**HORIZON®. HRZ-D MANUAL**  
**ADDENDUM**  
June 1980

ADDENDUM to: HRZ-D MANUAL, REVISION\_1

JUNE 4, 1980

PARTS LIST CHANGES

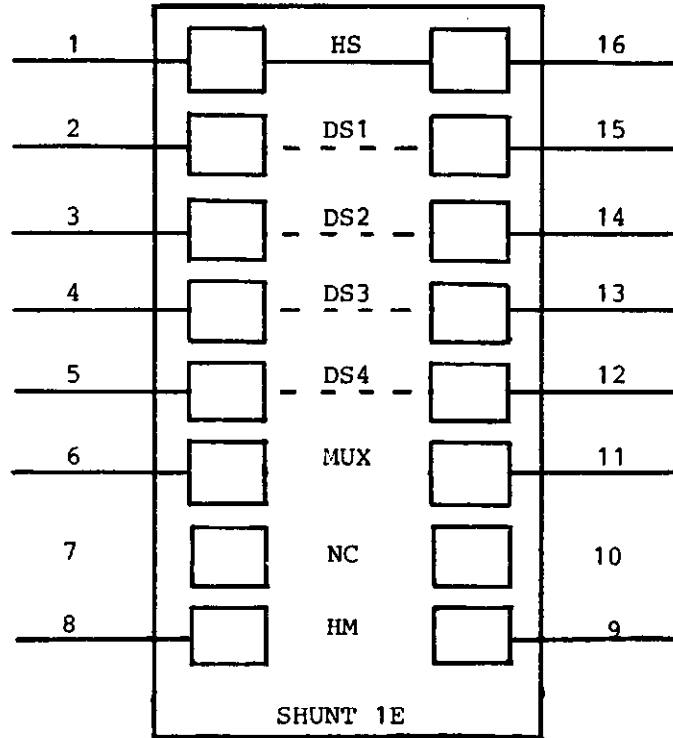
- A. On page 12, in the section titled DISK SUB-SYSTEM (MDS-H) PARTS LIST, delete two .047uf ceramic capacitors from the parts list.
- B. On Page 13, in the section titled SECOND DISK DRIVE (HRZ-DRV) PARTS LIST, delete two .047uf ceramic disc capacitors from the parts list.

## INSTRUCTION CHANGES

- A. On page 37, delete instruction D1 in the section titled DISK DRIVE #1 POWER REGULATION ASSEMBLY.
  - B. On page 38, delete instruction E1 in the section titled DISK DRIVE #2 POWER REGULATION AND CABLE ASSEMBLY.

DOUBLE-SIDED DRIVE SELECT CONFIGURATION

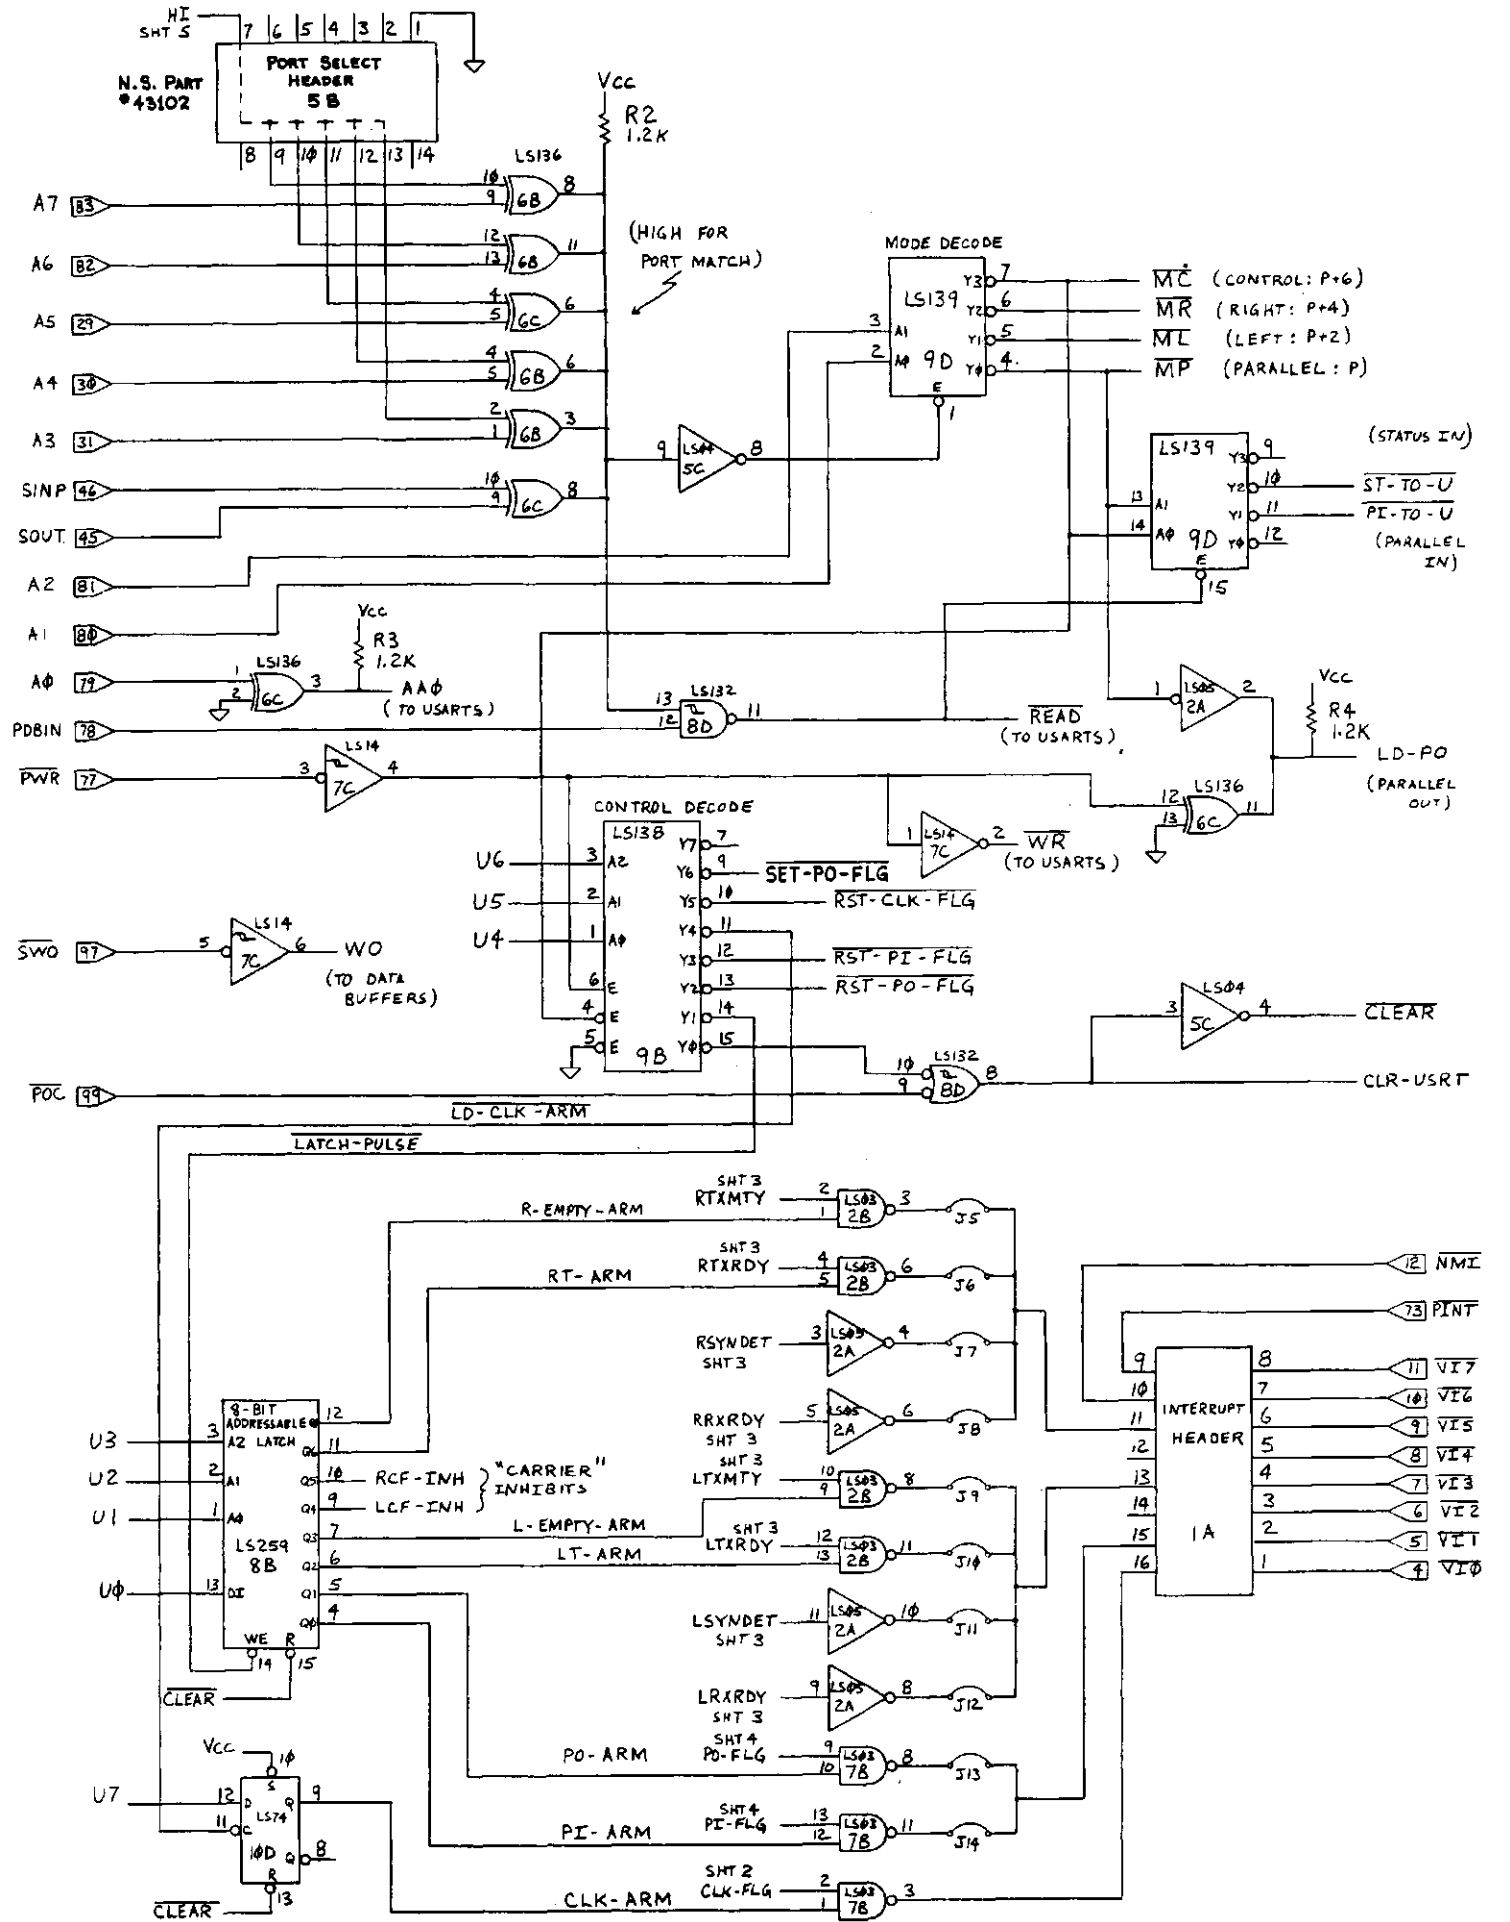
- 10) When using a doubled-sided drive, make certain that the shunt at 1E is properly configured. The connection for HS (Head Select) is connected between pin 1 and 16. To select drive one, (DS1), connect pin 2 to pin 15. To select drive two, (DS2), connect pin 3 to pin 14. To select drive three, (DS3), connect pin 4 to pin 13. To select drive four, (DS4), connect pin 5 to pin 12 and to pin 34 of edge connector J1; also, cut trace from pin 6 of the edge connector. Pin 6 and 11, the (MUX shunt), pins 8 and 9 (the HM shunt) and pins 7 and 10 should not be connected. For proper pin configurations, see the "Double-Sided Drive Select Configuration" diagram on the next page.

Only the drive plugged in at the end of the ribbon cable should have the DIP resistor network at location 2F plugged in. Additional drives plugged in along the cable should have the resistor package removed.

HORIZON MOTHERBOARD HRZ-MB-4	SHT
SERIAL PORTS	3 of 5
© 1977, NORTH STAR COMPUTERS, INC.

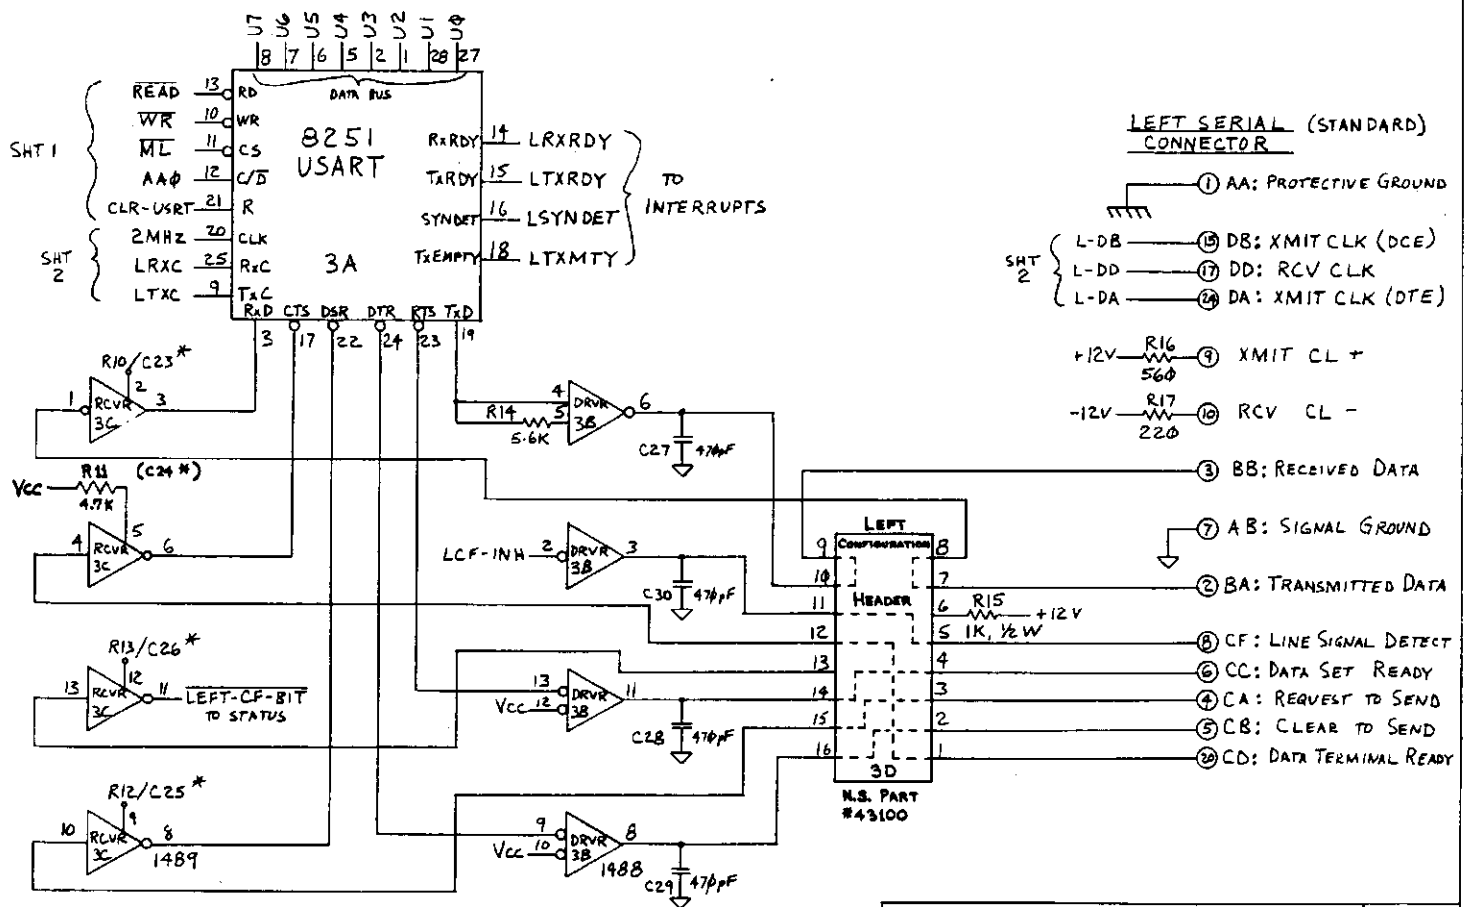
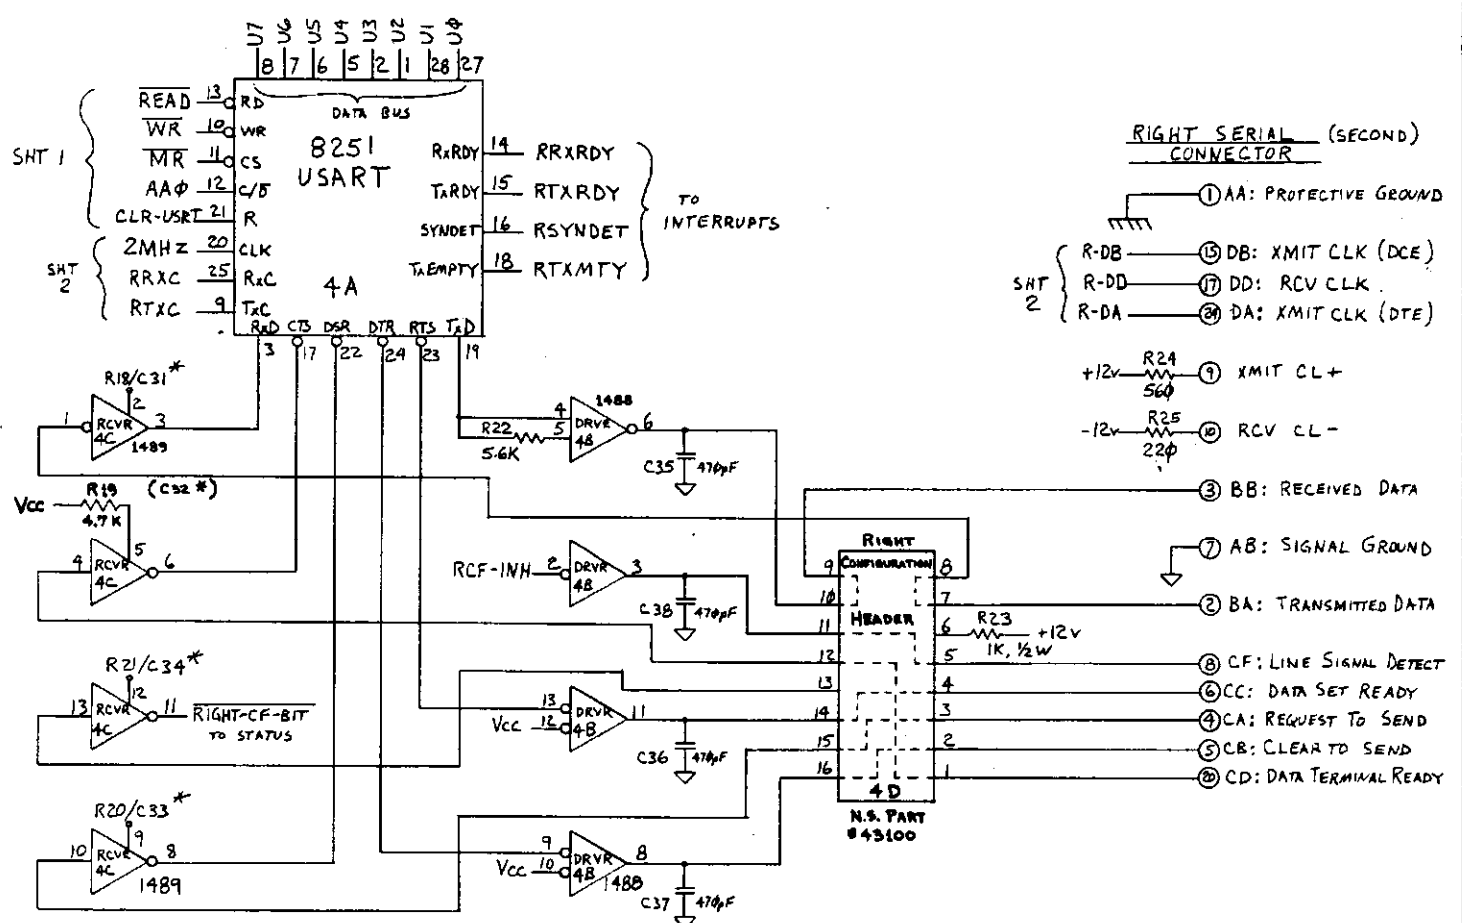
11) For all HORIZON Computer Systems containing motherboards marked "HRZ-MB-4", the following five pages of schematic drawings supersede pages 88, 89, 91, and 92 of the HORIZON Manual.

\* NOTE: TO EACH RS232 RECEIVER (12 PLACES), USER MAY ADD RESISTOR TO Vcc OR CAPACITOR TO GND. (4.7K RESISTOR NOMINALLY INSTALLED AT PIN # 5)
